## HISTORIC AND DESIGN REVIEW COMMISSION

**HDRC CASE NO:** 2016-391  
**ADDRESS:** 315 W LYNWOOD  
**LEGAL DESCRIPTION:** NCB 6386 BLK 6 LOT 13 THRU 22  
**ZONING:** R-5 H  
**CITY COUNCIL DIST.:** 1  
**DISTRICT:** Monte Vista Historic District  
**APPLICANT:** Lauren Diliberto/Don McDonald  
**OWNER:** Denis Karbach, Robert Kevin Brown  
**TYPE OF WORK:** Modifications to existing accessory structure  
**REQUEST:**

The applicant is requesting a Certificate of Appropriateness for approval to fill in three existing garage door bays, create 3 loggia door openings on the front façade, and alter two existing window openings on the left and front facades.

Exterior Elevations - Garage & Cabana Elevations

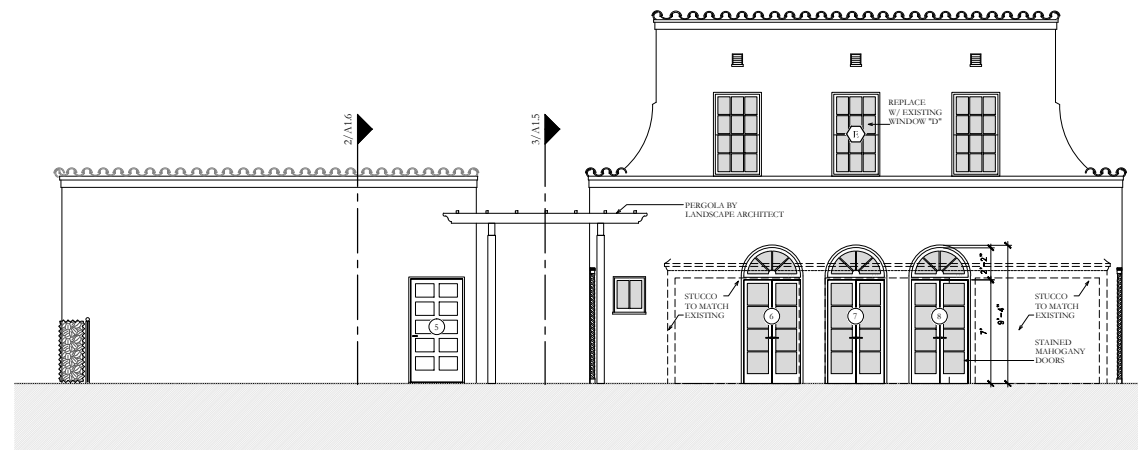
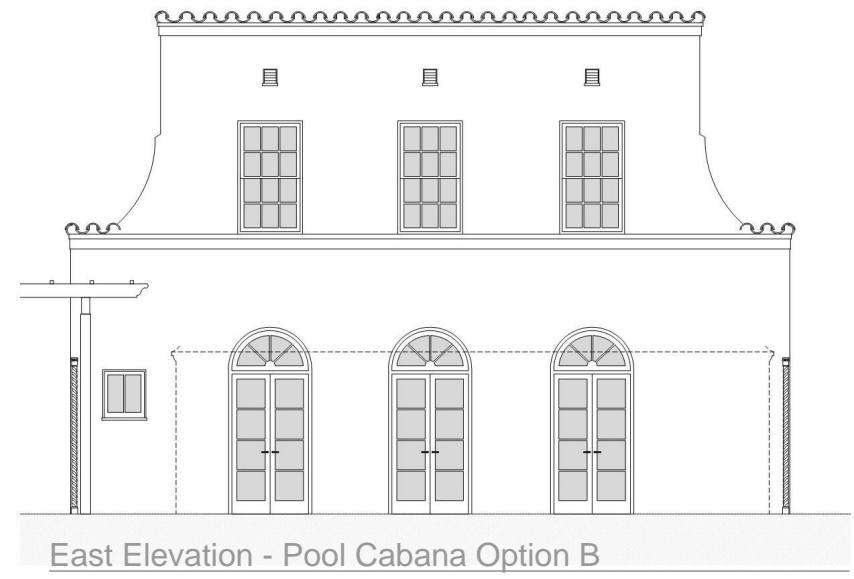
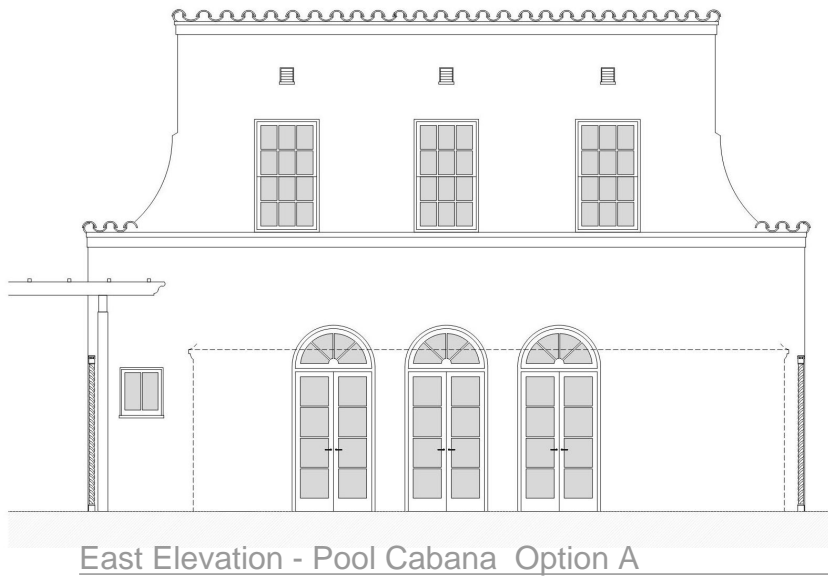
those enclosing the loggia on the main structure. According to the Guidelines for Exterior Maintenance and Alterations 6.B.i, openings should be preserved. The Carriage House is identified in the 1998 survey as contributing. Staff finds the existing garage contributing and recommends that original garage bays are retained. Staff finds the proposal to alter the garage bays is not consistent with the Guidelines.

- d. The applicant is proposing to install three arched loggia openings with loggia style doors. Staff finds the proposed arched doors alter the character of the garage.

- e. There are many successful examples of incorporating pedestrian doors into an existing garage door opening. The applicant should pursue a solution that is more consistent with the character and original use of the accessory structure.

Staff recommends denial of the proposed modification to the garage doors based on findings c through e. Staff recommends the applicant retain the existing garage bay openings and develop a solution that incorporates pedestrian access into the existing bays but continues to read as a garage door opening.

EXISTING EAST ELEVATIONS @ GARAGE  
315 W. LYNWOOD AVE. | MONTE VISTA, SAN ANTONIO  
DON B. MCDONALD, ARCHITECT, LTD.

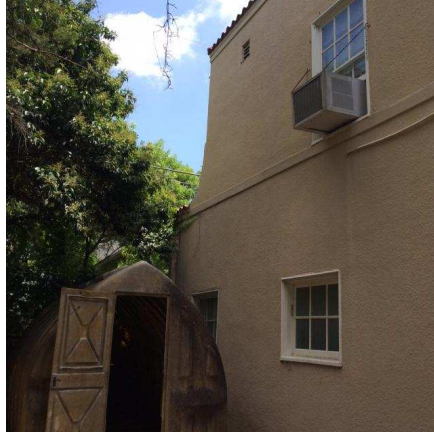
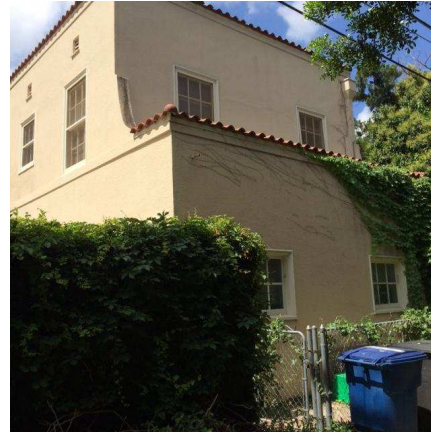
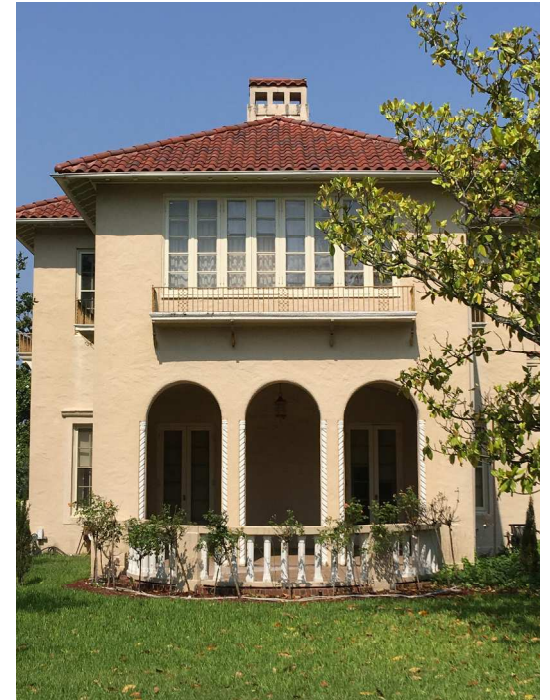
- f. On front façade of the existing garage there are 3 car bays, two 6 over 6 windows and one 3 over 3 window. On the left façade there is another 6 over 6 wood window. The applicant is proposing to remove the middle 3 over 3 window on the front façade and exchange it with the side 6 over 6 window. According to the Guidelines for Exterior Maintenance and Alterations 6.B.i, window openings should be preserved. Staff visited the site September 26, 2016, and found that the stucco had been patched below center window and is not original to the structure. Also, staff finds the left window is not seen from the public right-of-way. Staff finds the proposal to enlarge the front middle opening, using an existing historic window from the structure, to match the existing flanking windows appropriate.

Staff recommends approval of altering the windows based on finding f with the stipulation that the windows be re-installed to match the existing profile.
